# Memorandum

**To:** Bassett Creek Watershed Management Commission  
**From:** Barr Engineering Co. (Karen Chandler, P.E., and Jessica Olson, P.E.)  
**Subject:** Item 6B – Consider Approval of 90% Plans for 2025 Plymouth Creek Stream Restoration Project (CIP 2025 CR-P) – BCWMC December 18, 2025 Meeting Agenda  
**Date:** December 11, 2025  
**Project:** 23270051.65-6000-650

## 6B. Consider Approval of 90% Plans for 2025 Plymouth Creek Stream Restoration Project, Plymouth (CIP 2025 CR-P)

**Figure 1: Plymouth Creek Stream Restoration Reach (CIP 2025 CR-P)**

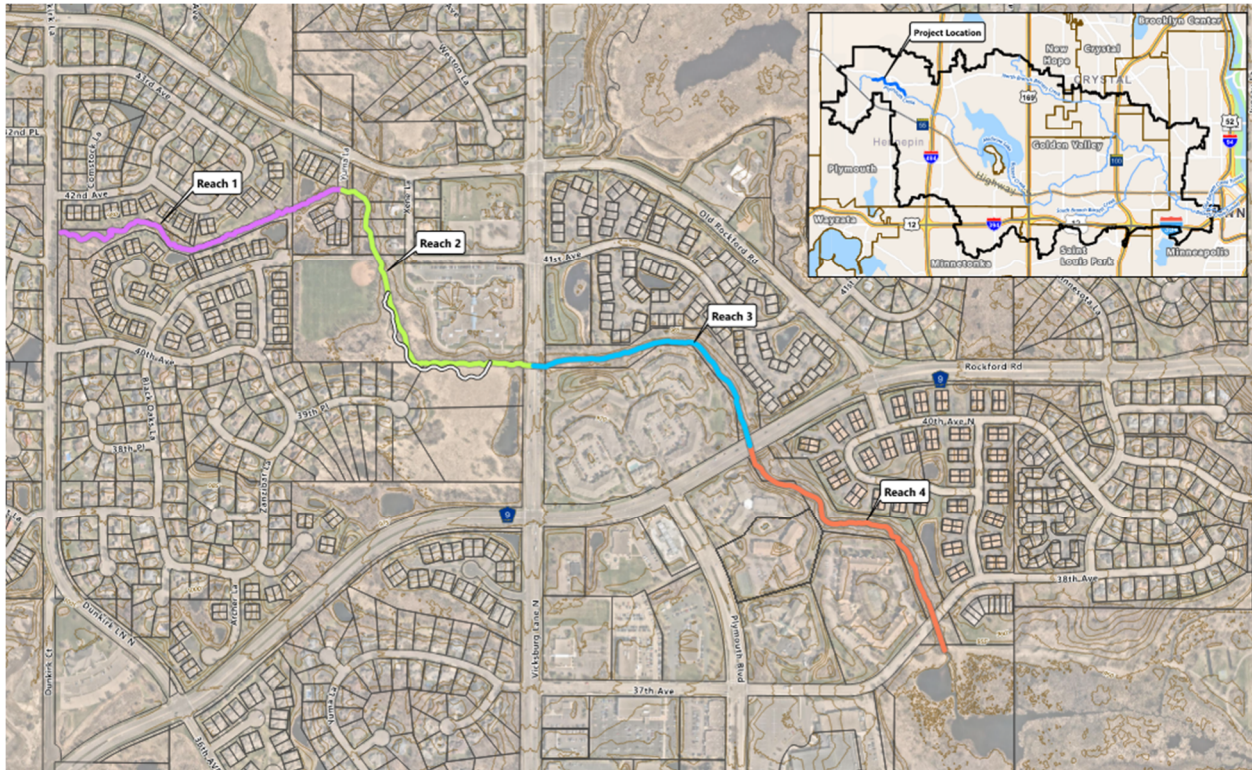
The BCWMC completed the Feasibility Report for Plymouth Creek Restoration Project (Barr, May 2024) to examine the feasibility of restoration within the project area in the City of Plymouth. The Plymouth Creek Stream Restoration project area is located along Plymouth Creek from Dunkirk Lane North, on the upstream end, to 38<sup>th</sup> Avenue North behind Plymouth Ice Center, on the downstream end (Figure 1). The feasibility report identified multiple measures for implementation including:
